Dogger Bank South Offshore Wind Farms

The Applicants' Responses to January 2025
Hearing Action Points (Revision 2) (Clean)
Submission for Deadline 1

Document Reference: 11.6

Plate 1 Example Main Onshore Converter Station construction compound showing key areas include Offices, Parking, Laydown, Secure Laydown (Cables), Topsoil Storage. The scheme also included additional works to expand pre-existing Bunds (landfill) with solid arisings.

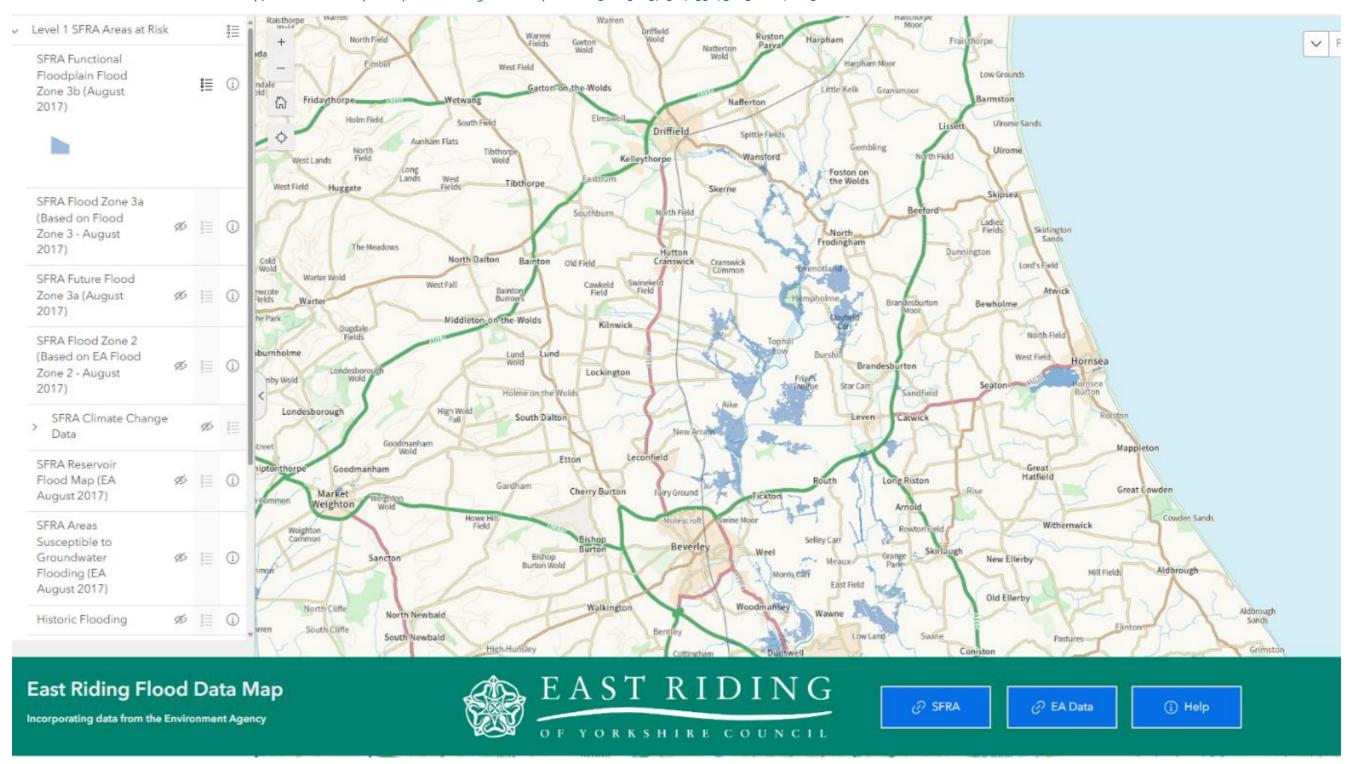
6	Provide the photomontage which has already been submitted to ERYC showing View Point (VP) ₃ [PDA-o10] and the construction compound extent, and show the	Chapter 5 Project Description [APP-072] has been updated at Deadline 1, to include dimensions of key equipment that would be located within the Temporary Construction Compounds (TCC's).
	likely vertical extent of any construction equipment.	As detailed in the Applicants Response to the Local Impact report (LIR), submitted at Deadline 1, VP3 has been updated to include a 2.4m high temporary fence and is included in Appendix A of the LIR [document reference 11.3].
7	Provide photographs of typical construction compounds to give an indication of the landscape and visual effects during construction.	Example construction compound photos are included in Appendix C of this document. However, it should be noted that all construction sites are different and these examples are not directly comparable due to geographical, supply chain and local logistical requirements.

As outlined in responses to Action Points from ISH2 on the 16th January and Supplementary Agenda Questions, this appendix provides examples of Temporary Construction Compounds to assist Interested Parties and the ExA to understand what may be implemented at the various locations set out for Temporary Construction Compounds within the Onshore Cable Corridor and Onshore Substation Zone. These are provided to assist Interested Parties, but it must be acknowledged that these examples are not directly comparable as compounds for the Projects will need to adjust to geographical, supply chain and local logistical requirements.
